1968 Corvette: Service News: Tune-up Specification Change

Subject: Tune-up Specification Change

Model and Year: 1968 Corvette with 427 cu. in. Engine, Manual Transmission and Air Conditioning

Date: February 1968, Volume 40, Issue #2

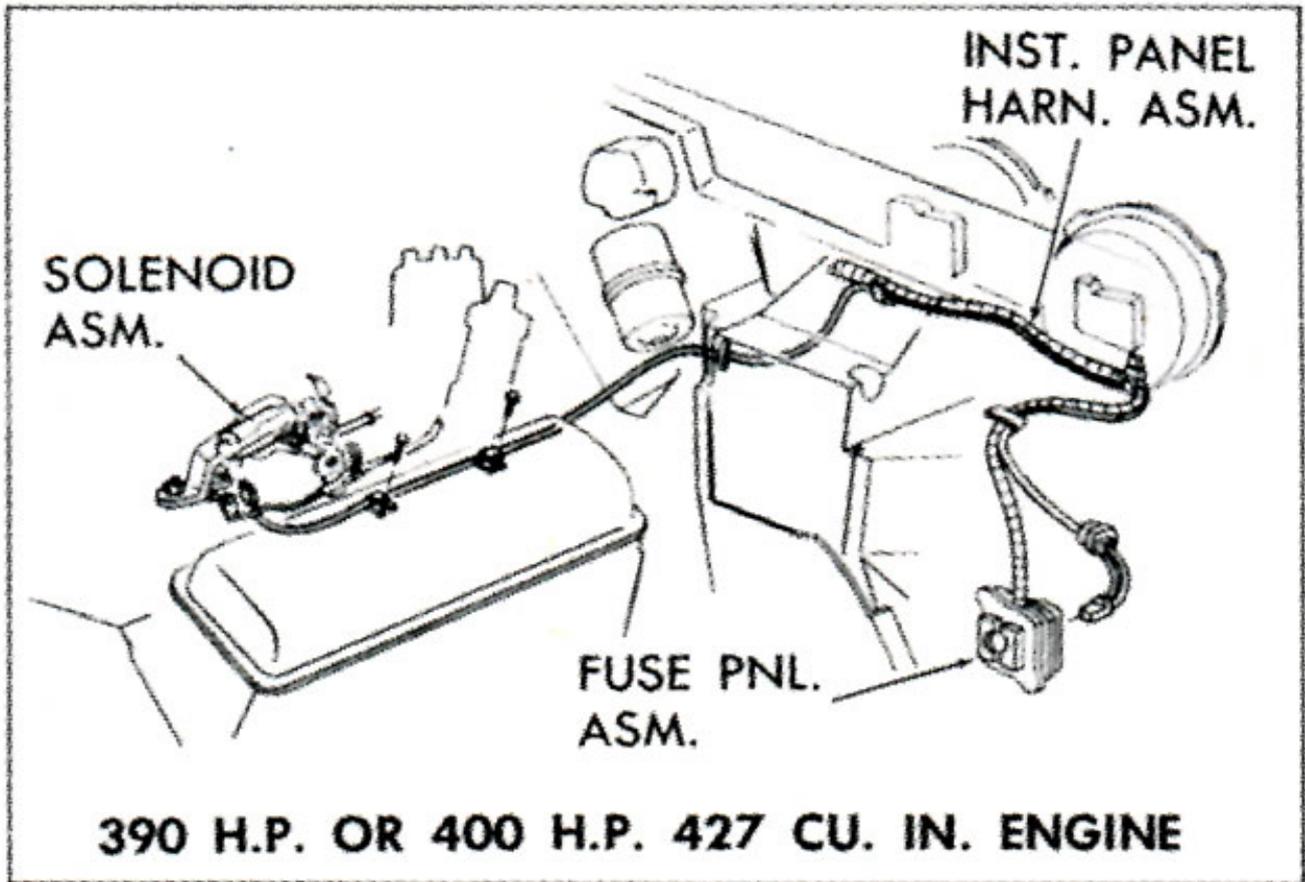
If the anti-dieseling solenoid on one of these vehicles requires replacement or adjustment, refer to the procedures given on Page 7 of this Service News issue. The 'Anti-Dieseling Solenoid Diagnosis Chart' on Page 7 of this issue should be of assistance in determining whether replacement is necessary. Figure 6 illustrates proper solenoid wire routing for either the 390 or 400 H.P. engine. The connector at the use panel should be inserted in the receptacle marked "IGN" for proper solenoid operation.

Fig. 7—Anti-Dieseling Solenoid Installation

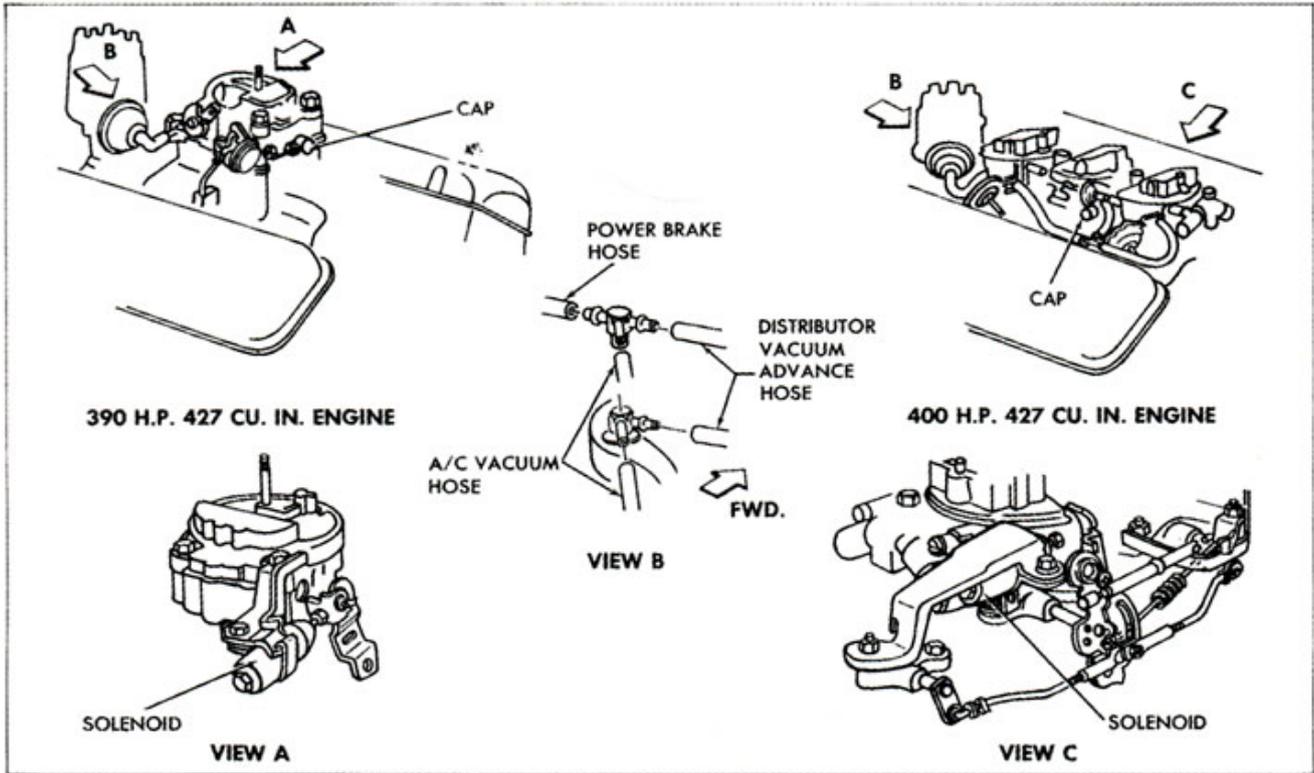
Figure 7 illustrates proper solenoid installation on both the 390 H.P. and 400 H.P. versions of the 427 cu. in. engine and also illustrates the correct intake manifold vacuum fittings for the full manifold vacuum distributor advance arrangement.
